Reference: Close-Out Survey

Re: Comprehensive Cardiovascular Consultants
NRC License 24-32459-01
Control No. 316317

Comprehensive Cardiovascular Consultants, Inc.
Decommissioning Survey of site: 3844 S. Lindbergh Blvd, Suite 250, Sunset Hills, MO
63127

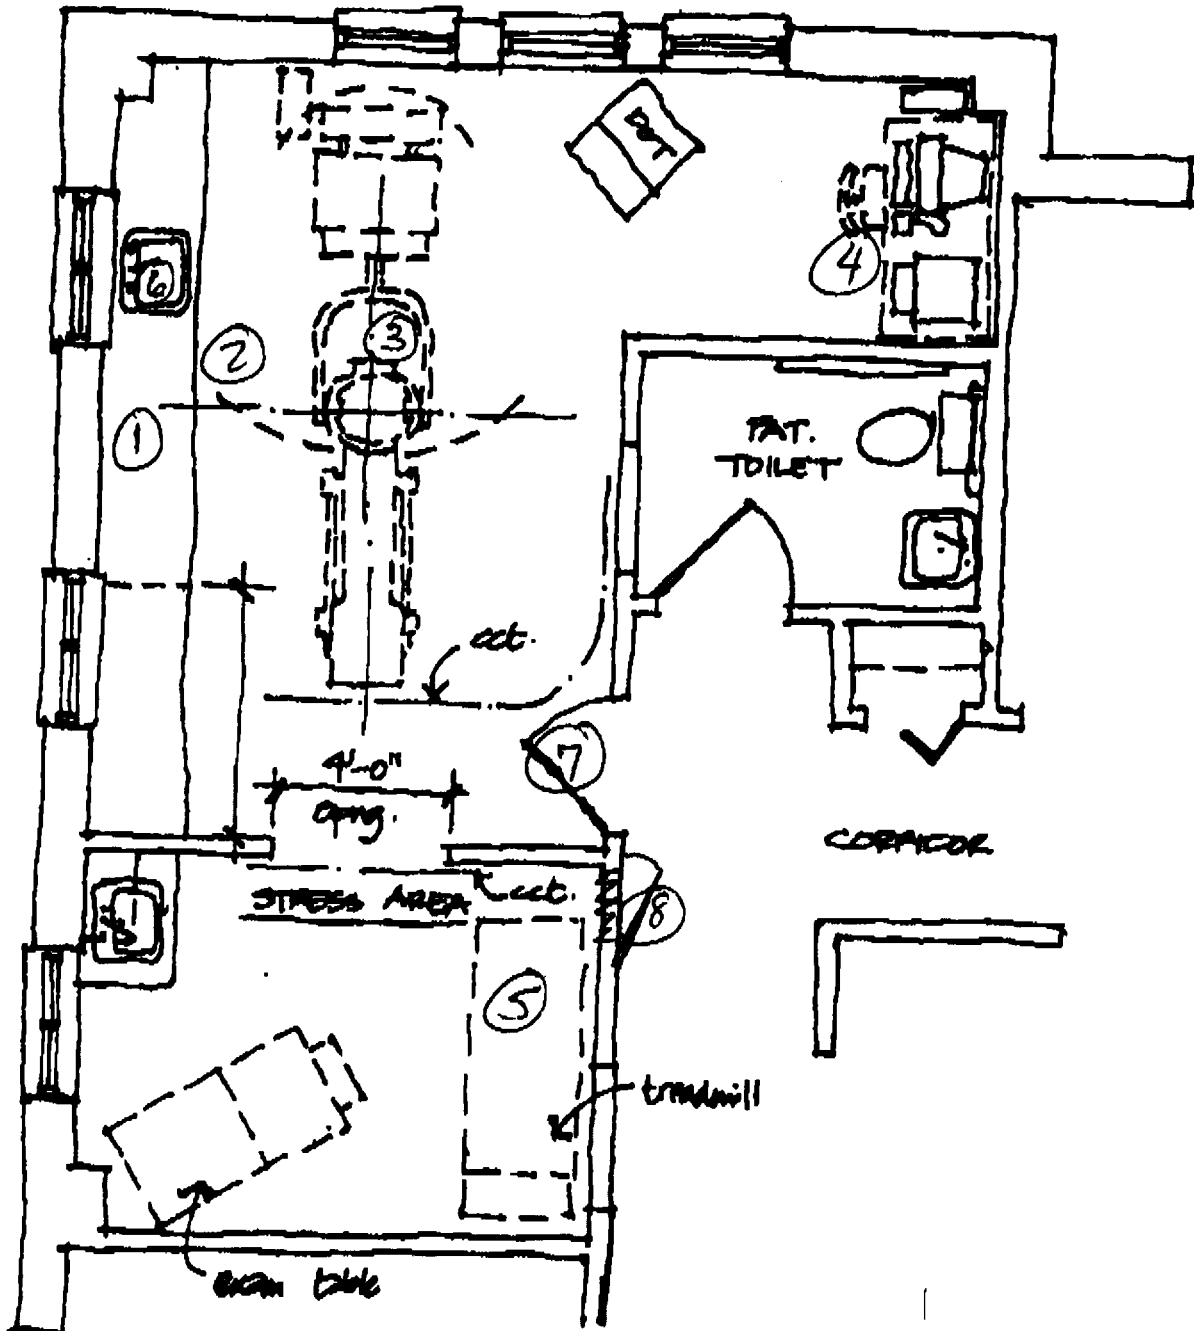
3. Please submit a sketch of the "old" facility located at 3844 South Lindbergh, Blvd., Suite 250, St. Louis, Missouri, with the G-M survey and wipe test results keyed to specific locations on the sketch.

1. The only "unsealed" sources used at the site were ^{99m}Tc and ^{210}Tl . None of these radionuclides were present at close-out. No ^{131}I in the form of NaI was present in the facility. See the inventory attached.
2. The Sealed Source Leak Test and Inventory, dated 6/6/07, (Attachment 2-a), is a copy of the leak test results that were current at the time of the close-out survey for the sealed sources used or stored at the said facility. Attachment 2-b shows additional leak test results performed Oct. 01, 2003, as the only other historical reference data.
3. Attachments 3a and 3b provide a sketch of the facility with G-M and wipe test results keyed to the specific locations on the sketch.
4. The instrument used to perform the wipe tests is the Atomlab 450.

1 Hot Lab Counter	0.02 mR/hr
2 Hot Lab Floor	0.02 mR/hr
3 Camera Area	0.02 mR/hr
4 Computer Area	0.02 mR/hr
5 Treadmill Area	0.02 mR/hr
6 Hot Lab Sink	0.02 mR/hr
7 Imaging Room Door	0.02 mR/hr
8 Stress Lab Door	0.02 mR/hr
